RESPONSE TO REQUEST FOR ADDITIONAL INFORMATION

APR1400 Design Certification

RAI No.: 339-8415

SRP Section: 15.01.05 - Steam System Piping Failures Inside and Outside of Containment (PWR)

Figure Minimum DNBR vs Time on LOOP

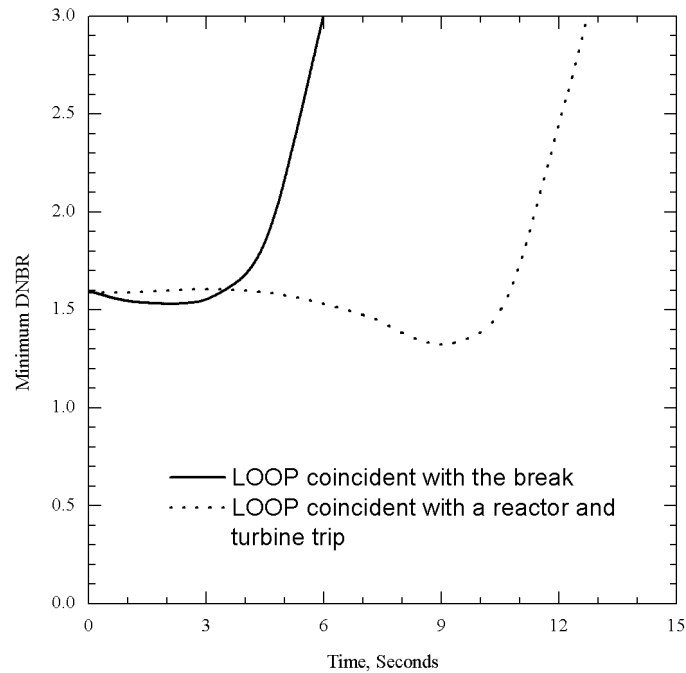
Modeling of the loss of offsite power (LOOP) for the steam line break (SLB) event is treated differently between the return to power (RTP) and departure from nucleate boiling ratio (DNBR) analysis. In particular, the RTP analysis assumes a LOOP coincident with the break and the DNBR analysis assumes a LOOP coincident with a reactor and turbine trip. Since a LOOP coincident with the break would result in a lower reactor coolant system (RCS) flow at the time of minimum DNBR, NRC staff is questioning whether the DNBR case presented in the design control document (DCD) is bounding. NRC staff requests that KHNP conduct a SLB DNBR analysis assuming a LOOP coincident with the break to verify that the limiting DNBR case presented in the DCD Section 15.1.5 is bounding.

A LOOP coincident with the break causes an early reactor trip on the core protection calculator (CPC) low reactor coolant pump (RCP) shaft speed trip. SLB DNBR analysis assuming a

LOOP coincident with a reactor and turbine trip generates more adverse results than assuming a LOOP coincident with the break (Figure 1). Therefore, the limiting DNBR case presented in the DCD Section 15.1.5 is bounding.

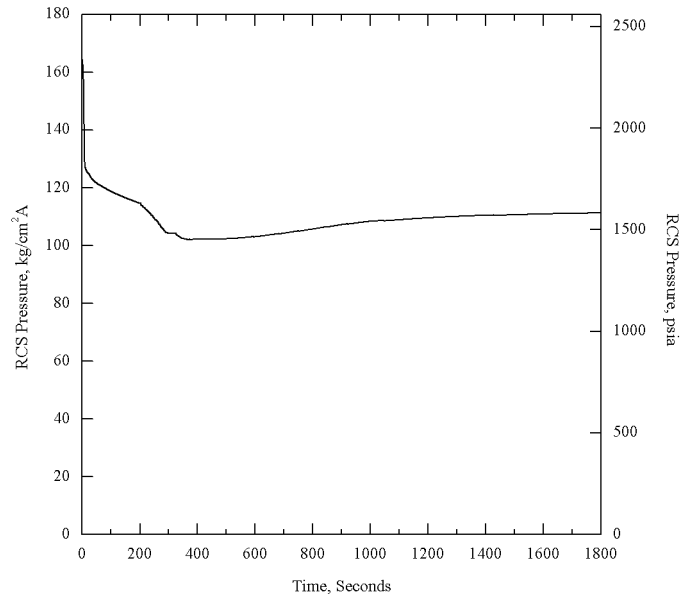
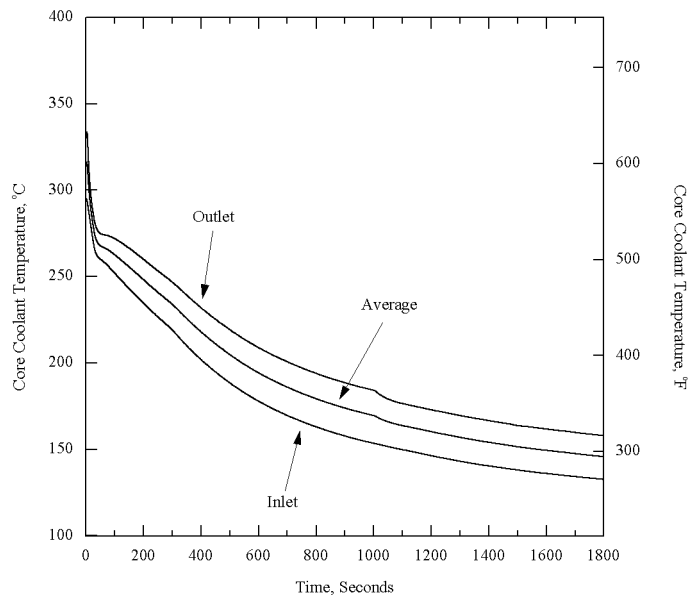
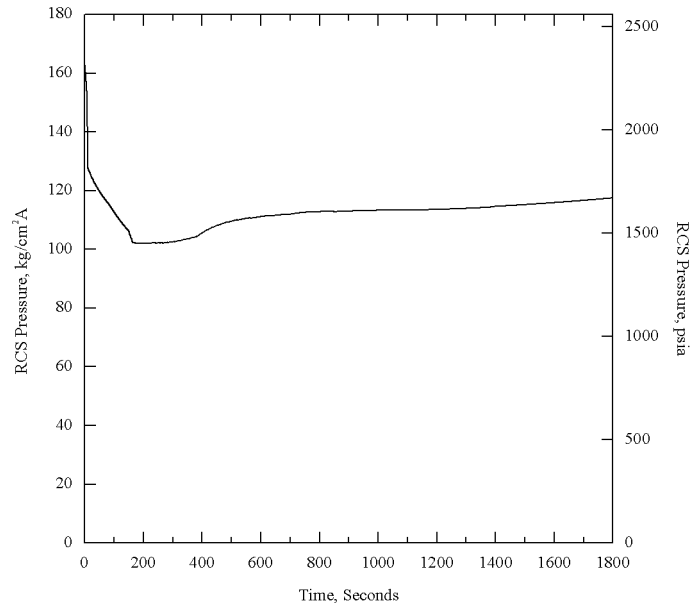
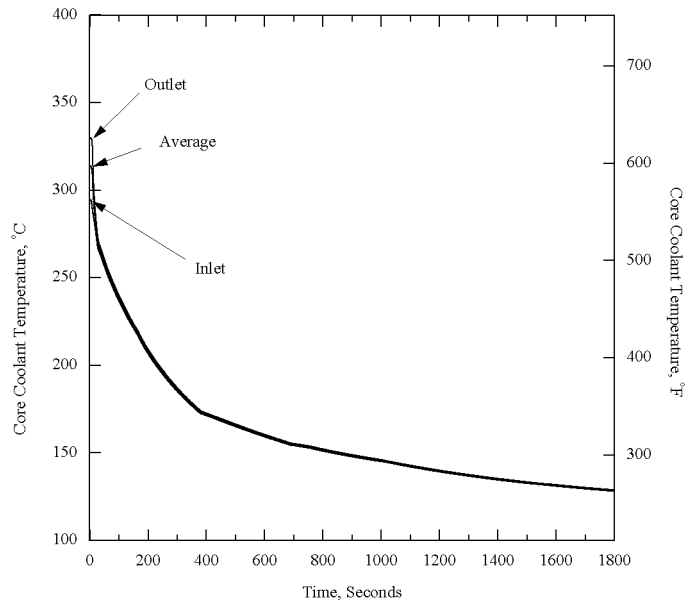
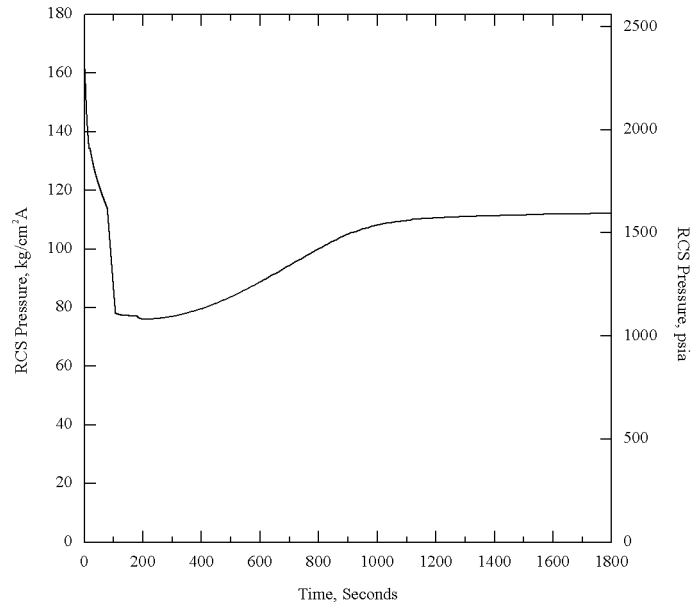
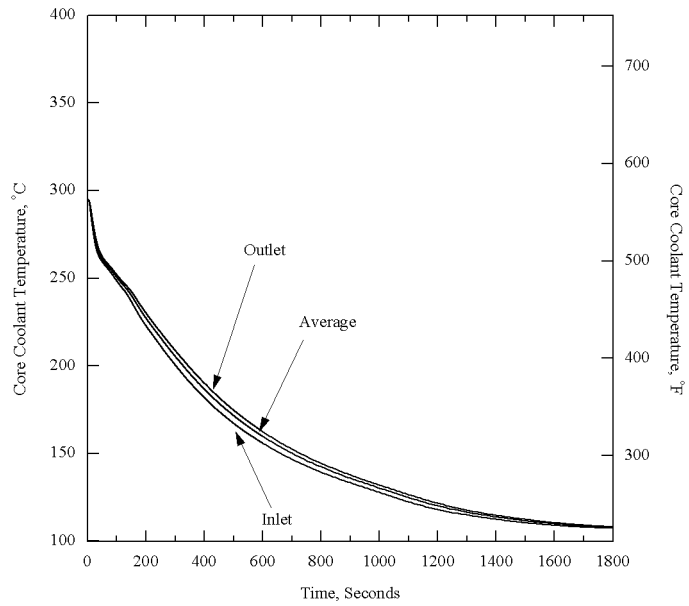
Section 15.1.5 of the design control document (DCD) does not address SRP Section 15.1.5 acceptance criteria associated with GDC 31. Additionally, the figures contained in DCD Section 15.1.5 do not extend beyond 10 minutes. Therefore, NRC staff cannot verify that the RCS temperature remains above the temperature limit corresponding to safety injection shutoff head on the cooldown pressure-temperature limit curve for 30 minutes (the time at which operator action is credited). NRC staff requests Section 15.1.5 of the DCD be updated as required to demonstrate that the pressure-temperature limits are not violated during the limiting steam line break event.

During the SLB accident, since a fast decrease of the RCS pressure at the initial stage causes the safety injection, the peak core reactivity occurs within 10 minutes as shown in Figures 15.1.5-1.7, 15.1.5-2.7, 15.1.5-3.7, 15.1.5-4.7 and 15.1.5-5.6. Therefore, the figures contained in DCD Section 15.1.5 need not extend beyond 10 minutes. For P-T limits, as shown in Figures 1 through 10, the RCS temperature remains above the temperature limit corresponding to safety injection shutoff head on the cooldown pressure-temperature limit curve for 30 minutes.
